TMI-09-107
November 9, 2009

Three Mile Island Nuclear Station, Unit 1
Renewed Facility Operating License No. DPR-50
NRC Docket No. 50-289

Subject: Response to Request for Additional Information Regarding Generic Letter 2004-02

Figure 2: Floor area where large pieces of Nukon® would transport to the sump

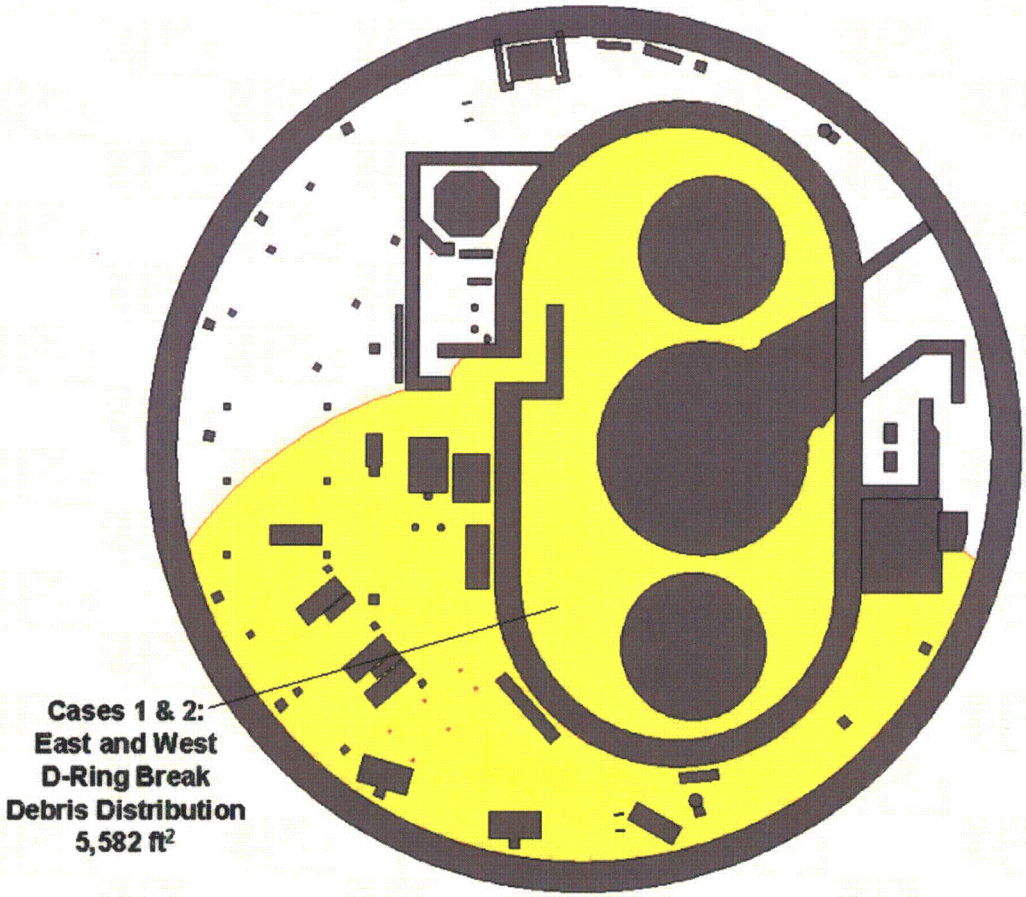
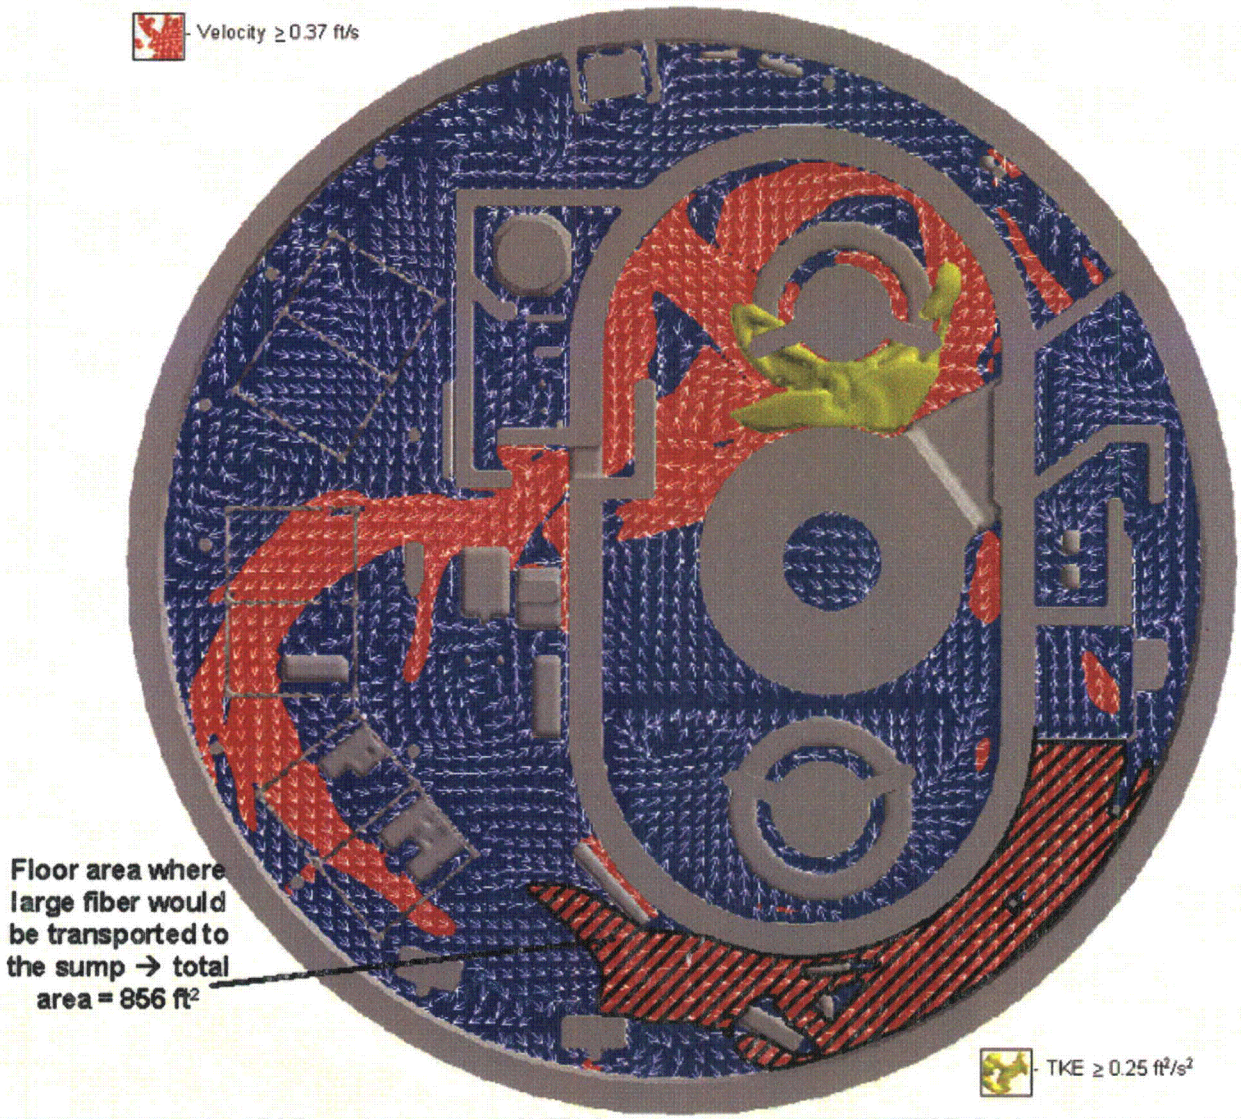
The staff requested that the licensee provide the post-transport size distributions for the reflective metal insulation, and jacketed and unjacketed Nukon® insulation debris with justifications for the transport fractions (e.g., erosion effects). The GSI-191 Safety Evaluation Report, "Pressurized Water Reactor Sump Performance Evaluation Methodology," states that erosion may be neglected if the licensee follows the baseline methodology and considers transport fractions for large debris pieces. The staff noted one apparent inconsistency in the information that was provided regarding the transport of large pieces of fiberglass. Specifically, the information provided in Table 2 of the RAI response indicates that a transport percentage of

15% for large pieces was assumed; however, a note to Table 2 indicates that large pieces are not transported to the sump, and that erosion is also not considered. Further, the licensee has not provided adequate justification (e.g., computational fluid dynamics and experimental debris transport metrics, test results, etc.) for the 15% assumption. The staff requests that the licensee clarify the transport fraction assumed for large pieces of fiberglass debris, state whether it transports as intact large pieces or eroded fines, and provide the technical basis used to derive this transport fraction. Please also clarify whether the transported large debris was modeled in the head loss testing conducted for TMI-1 and identify its prepared size distribution.

A transport fraction of 15% for large pieces was determined in the TMI, Unit 1 Debris Generation Calculation. The CFD model showed that turbulence in the pool is not high enough to suspend large pieces of Nukon® throughout most of the pool. Since the large pieces of Nukon® would settle in most of the pool, the tumbling velocity is the predominant means of transport. The large pieces of Nukon® were assumed initially to be uniformly distributed between the locations where it would be destroyed and the sump (Figure 1, below). This area was overlaid on top of the plot showing the tumbling velocity and flow vectors to determine the recirculation transport fraction. The area where large pieces of Nukon would transport is approximately 15% (856/5582 ft^3) of the total initial distribution area (Figure 2, below).

The 15% of large pieces assumed to be transported was included in the total quantity of Nukon® transported to the sump as identified in Table 2 (Reference 3). This total quantity of Nukon® (199 ft^3) was used to determine the quantity of debris to be used in the head loss testing based on the appropriate scaling factors. All Nukon® debris used in the head loss test was prepared in the same manner, regardless of whether it was assumed to be transported as small or large pieces. The debris preparation procedure was described in the previous response to RAI 7 (Reference 3) and additional information is provided in the response to USNRC Question 3, below.

Photograph 1: Fiberglass shreds in size Class 5

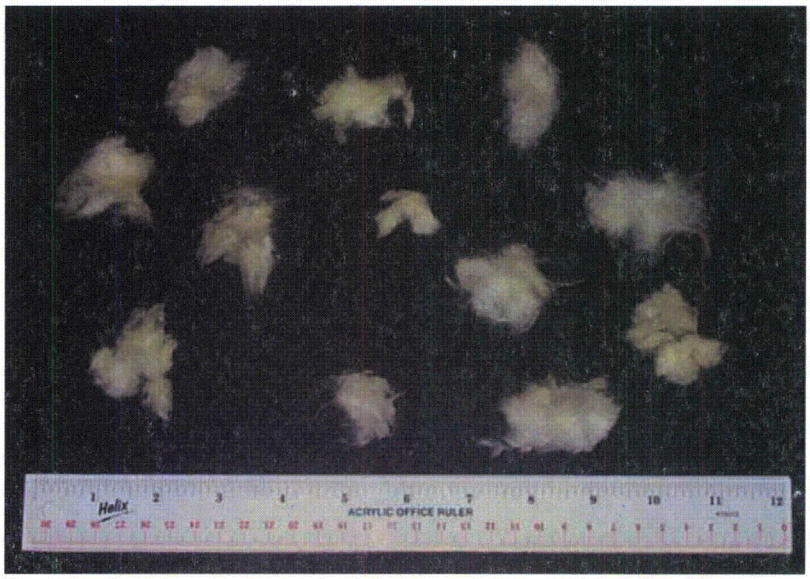
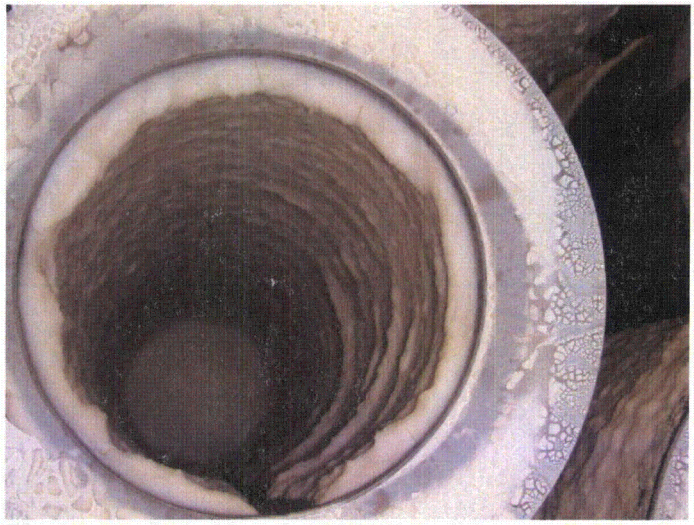
The staff requested additional information on the size distribution of fibrous debris used during testing and requested that the licensee provide information that justified the fibrous debris used during testing. The licensee stated that small fines were used. However, the staff guidance requests that the fibrous debris sizing be further broken down into small and fine debris categories. Current staff guidance states that thin bed testing should be conducted with only fine (easily suspendable) fiber (until all predicted fine fibers have been added to the test). The licensee response to the RAI did not address the referenced guidance. It is possible, but unlikely, that a thin bed test conducted in accordance with the latest guidance could result in

higher head losses than were attained during the TMI-1 testing. It is more likely that the full load test, if conducted with prototypically sized fiber could have resulted in higher head losses. The licensee should provide information that justifies that the head losses attained during testing were not influenced non-conservatively by the sizing of the fibrous debris used during testing.

It should be pointed out that the USNRC witnessed the March 2007 Test 1B as documented in a USNRC Trip Report (Reference 9). This report indicated that settling occurred with the small pieces in Test 1B. As a result of this report, Alion implemented additional attention to "agitation" in the November 2007 testing to facilitate transport to the sump screen. The differences in settling between the two tests are illustrated in the response to USNRC Question 6, below. As a result of the preferential sedimentation of the small debris fragments from within the "small-fine" debris used for the testing, the debris actually reaching the screen tended to be comprised predominantly of "fine" debris. This is consistent with the conditions preferred by the USNRC March 2008 guidance (Reference 6).

Review of the 2006 Tests 1, 3, 4 and 2007 Test 1B indicates that under a variety of load conditions, the screen design is not susceptible to thin-bed effects. This is consistent with Alion's experience with this particular screen design. This is due to the non-uniform approach velocity and debris deposition. The March 2007 1B testing, as well as the earlier 2006 testing, did notice debris settling of small pieces; however, the screen was completely covered in fines, which is a realistic scenario to produce a thin-bed effect considering some settling of small pieces. In all four cases involving small debris quantities with sedimentation of the larger "small/fine" debris fragments (2006 tests 1, 3, and 4 and 2007 test 1B), the thin-bed head loss is consistently much lower than the limiting load cases head losses. Based on these results, it can be concluded that the thin-bed does not produce limiting head losses. In particular, 2006 Test 3 and 2007 Test 1B produced essentially identical results, and both tests were completely covered in "fines." Photographs 2 and 3 were taken, by Alion, following draindown after the USNRC witnessed 2007 Test 1B. Note the uniform deposition and "fine" quality of the debris at the screen surface in Photograph 4.

Figure 3: LPI NPSH - Maximum Reactor Building Cooldown – Case I

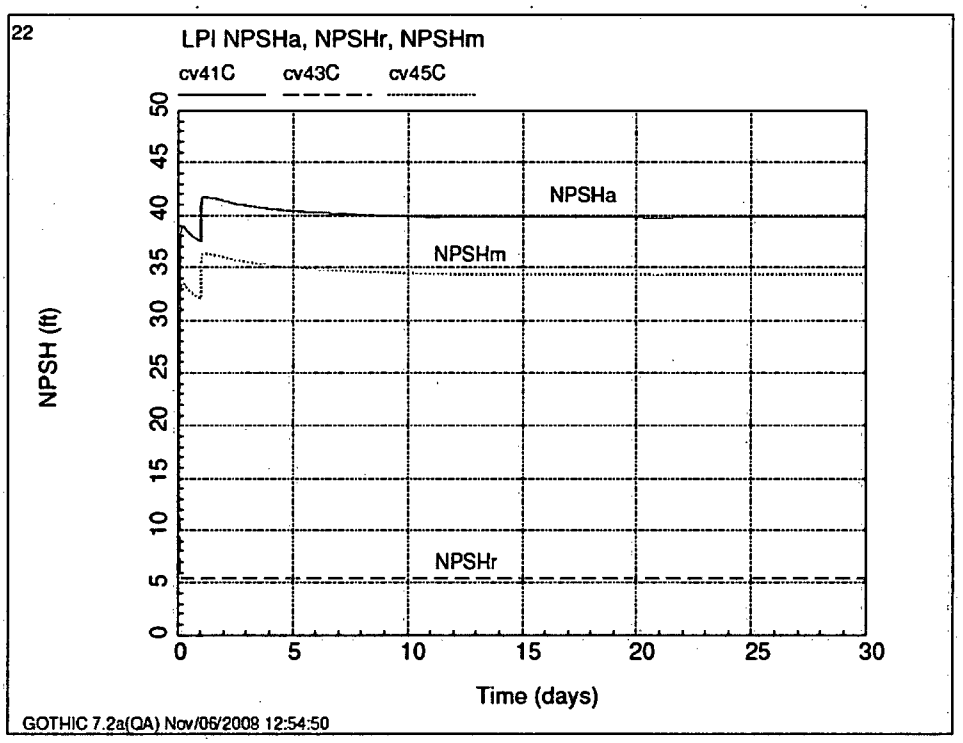
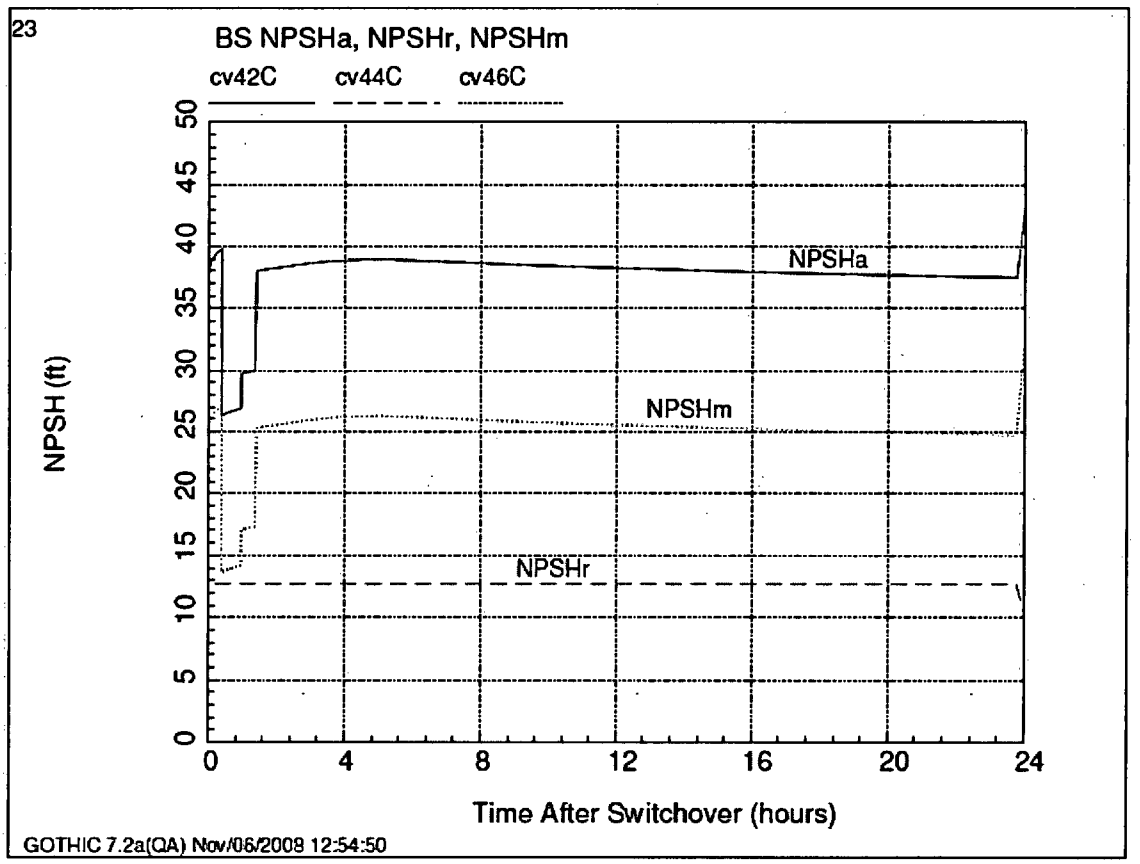
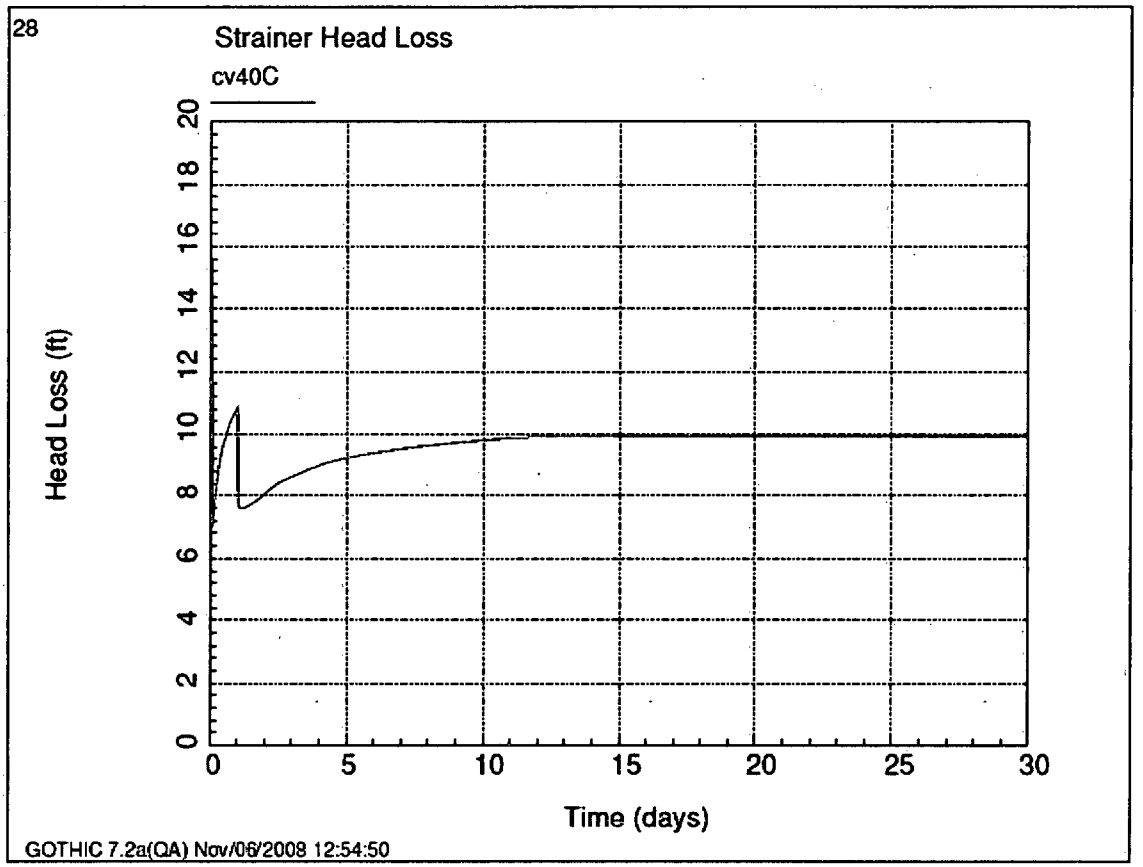
The staff requested additional information on how the extrapolation of head loss results to the strainer mission time would affect the head loss evaluation. The licensee provided additional information that clarified some aspects of the need to perform an extrapolation of the data to the pump mission time. The licensee response to the RAI is reasonable. In addition, the rate of increase of head loss over the last 12 hours was very small such that less than one foot additional head loss would likely occur over the strainer mission time. However, the TMI-1 supplemental response states that the limiting NPSH margin for the low pressure injection (LPI) pump single operation is 0.1 ft. This is a relatively small margin. The variance of margin related to time was not provided. Because of the low margin available, the licensee should verify that the evaluation of the head loss test data did not include a non-conservative assumption regarding extrapolation that could affect the available pump margin throughout the mission time.

The maximum stable strainer head loss measured after the addition of the calcium phosphate precipitates in the TMI Unit 1 head loss test was 1.7 ft. As discussed in the previous response to Issue 3f.10 (Reference 1), the test head loss is adjusted for flow rate and temperature when applied in the NPSH analysis. The adjusted head loss due to the total amount of calcium precipitates is applied from the beginning of recirculation to the time when sump temperatures reach 140^{0}F. This includes the time of minimum NPSH margin, which occurs in the first few hours following initiation of sump recirculation. No non-conservative assumptions that could affect the available pump NPSH margin were identified in the application of the head loss test data to the time in which sump temperatures are above 140^{0}F.

The adjusted head loss based on the maximum observed value of 21.3 ft is applied in the NPSH Margin Analysis when sump temperatures reach 140^{0}F. The increase in head loss at 140^{0}F is applied as a step change and is not phased in over time. Following the step change in strainer head loss, the minimum NPSH margin for the LPI pumps is 11.9 ft (See Tables in Attachment 5). The minimum NPSH margin for the BS pumps is 13.6 ft (See Tables in Attachment 5). The minimum margins for both pumps occur in the maximum cooldown Case I and are coincident with the step change at 140^{0}F. NPSH margin for both pumps increases later in the event as shown in the figures below. With the significant NPSH margins that are available at the lower temperatures, no non-conservative assumptions that could affect the available pump NPSH margin were identified in the application of the head loss test data to the time in which sump temperatures are below 140^{0}F.

The maximum strainer head loss is also evaluated to ensure that the maximum strainer design differential pressure is not exceeded. The maximum strainer head loss always occurs after the sump temperature reaches 140^{0}F, but is dependent upon the timing of termination of BS flow and throttling of LPI flow. As discussed in the previous RAI response to Issue 3f.10 (Reference 1), credit is taken for operator action to secure the BS pumps and reduce LPI flow to ensure the structural limit of 16.15 ft (7 psi) is met for all cases. The maximum strainer head loss of 15.6 ft occurs for the maximum cooldown Case I (See Tables in Attachment 5). Strainer head loss decreases and remains below this value due to the action of securing the first BS pump and subsequent operator actions to throttle LPI flow as shown in the plot below. The operator actions credited for maintaining strainer differential pressure below the design value were shown to be effective. No non-conservative assumptions that could affect the maximum strainer differential pressure were identified in the application of the head loss test data to the time in which sump temperatures are below 140^{0}F.

Figure 6: TMI, Unit 1 Containment Sump Configuration

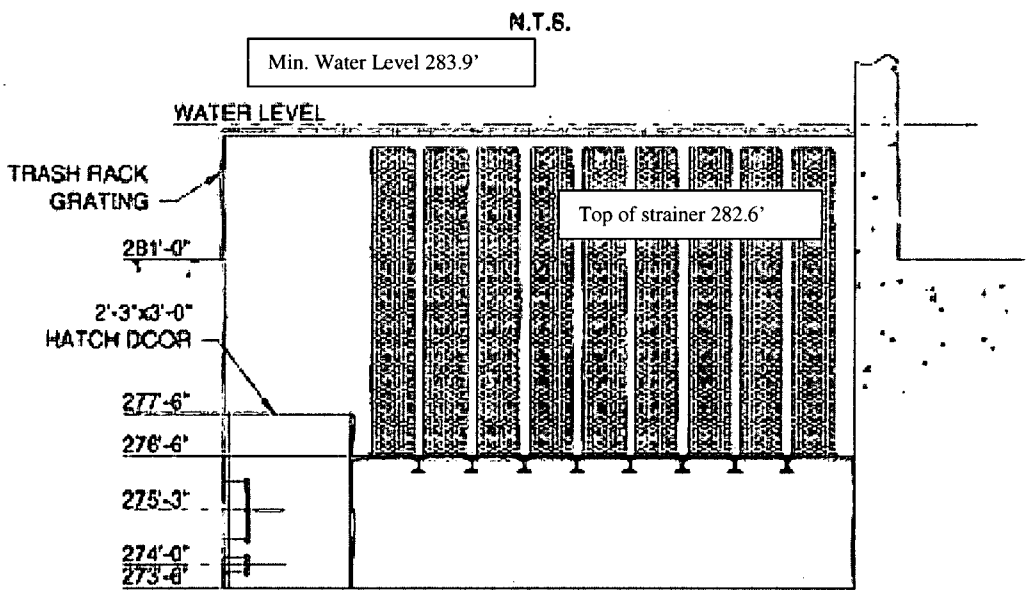
The staff requested additional information on whether containment overpressure was credited for the strainer flashing evaluation. The licensee provided additional information in this area, but it seemed that the question was not understood. The licensee evaluated flashing at the pump suction, but did not address potential flashing in the debris bed or within the strainer. Flashing within the strainer or debris bed can result in additional head losses. The licensee should verify that the potential for flashing at the strainer has been evaluated or provide the parameters such that the staff can verify that flashing will not occur. The minimum margin to flashing at the strainer should be provided. For example, provide strainer submergence, sump temperature, and strainer head loss as a function of time. If required, provide the minimum available containment pressure at the evaluated times.

Based on the review of the vertically oriented screen design in the sump pit, the greatest potential for flashing occurs at the top of the strainer due to the minimum submergence. An illustration of the TMI, Unit 1 strainer is provided in Figure 6. The minimum water level is at elevation 283.9' and the top of the strainer top hat is at elevation 282.6' which provides 1.3' of submergence to the top of the strainer top hat.

As described in the previous response to Issue 3o.2.9.i (Reference 1), the head loss across the strainer at temperatures above 140°F is based on the contribution of calcium phosphate precipitates. As described in the Response to Issue 3f.13 (Reference 1), the measured debris head loss is adjusted based on the temperature of the fluid. Due to the effect of fluid density and viscosity, the debris head loss increases as temperature decreases. The submergence of the strainer is greater than the debris head loss until the sump temperature decreases to approximately 141°F. For the temperatures around 141°F, the fluid pressure determined per criteria 2, above, is above the vapor pressure (see example below for temperatures at or below 140°F). Therefore, flashing does not occur for temperatures above 140°F.

As described in the response to Issue 3o.2.9.i (Reference 1), the head loss across the strainer at temperatures below 140°F includes the contribution of aluminum based precipitates. This results in a significant increase in strainer head loss as discussed in the response to USNRC Question 4 (RAI 9). As described in the Response to Issue 3f.10 (Reference 1), operator actions to secure the BS pumps and reduce LPI flow will maintain the strainer DP below the strainer design limit. The flashing evaluation conservatively uses the strainer design DP (16 ft) as the maximum debris head loss. The debris head loss is greater than the submergence of the strainer below 140°F, therefore criteria 2 is applied. The fluid pressure at the top of the strainer is slightly greater than 7 psia [13.7 psia + 0.5 psia (or 1.3 ft.) – 6.9 psia (or 16 ft.)], which is well above the vapor pressure of 2.9 psia. Therefore, flashing does not occur for temperatures below 140°F.
